URGENT: Medical Device Correction Update
Follow up to November 2021 Notification (Phase 2)
Synergy™ Cranial (9733763) and StealthStation™ Cranial (9735585)
Biopsy Depth Gauge Cycle View Inaccuracy

16 August 2022

URGENT: Medical Device Correction **Synergy™ Cranial (9733763) and StealthStation™ Cranial (9735585)** **Biopsy Depth Gauge Cycle View Inaccuracy**

Figure 1 Biopsy Depth Gauge Inaccuracy seen in Navigate Task

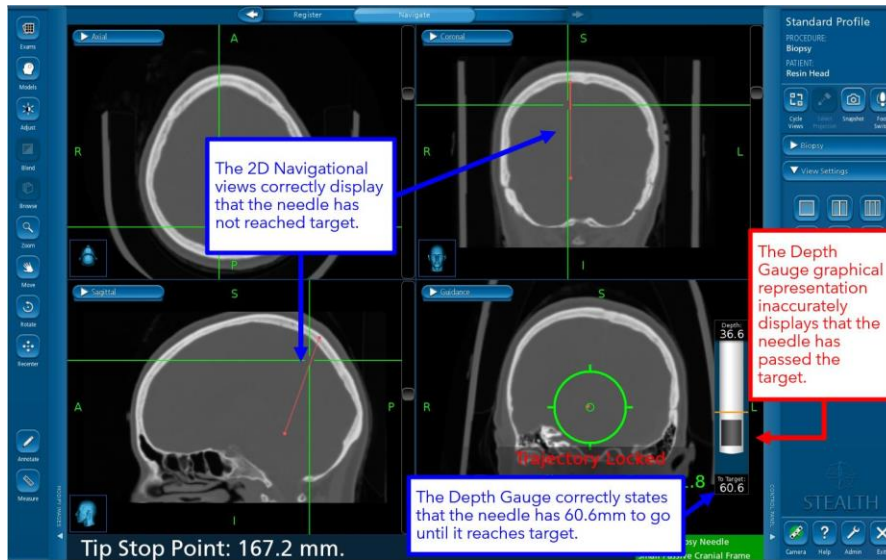
On June 9, 2021, a complaint was reported to Medtronic that during navigation in a Cranial Biopsy Procedure, the user may encounter an anomaly with the Biopsy Depth Gauge graphical display in the software. The software can enter a state where the Biopsy Depth Gauge is no longer synchronized with the rest of the navigational information on the screen and displays an inaccurate position of the biopsy needle.

If performed, these actions may cause the Biopsy Depth Gauge graphical display to incorrectly depict the tip of the biopsy needle. The graphical depiction of the biopsy needle may appear in a position relative to the plan target that does not represent the actual physical position of the biopsy needle, which may result in potential biopsy of healthy tissue or damage to critical structures.

- **Step 1:** Obstruct the camera field of view of the biopsy needle or reference frame to **cause red status**.
- **Step 2: Return to green status** by no longer obstructing camera field of view of the biopsy needle and reference frame.
- **Step 3:** Use the **Cycle Views** icon to refresh guidance view and confirm that the biopsy depth gauge graphic matches the distance to target values and the position to target information provided by the 2D crosshairs.
- **Step 4: Visually confirm accuracy** before proceeding with navigation.
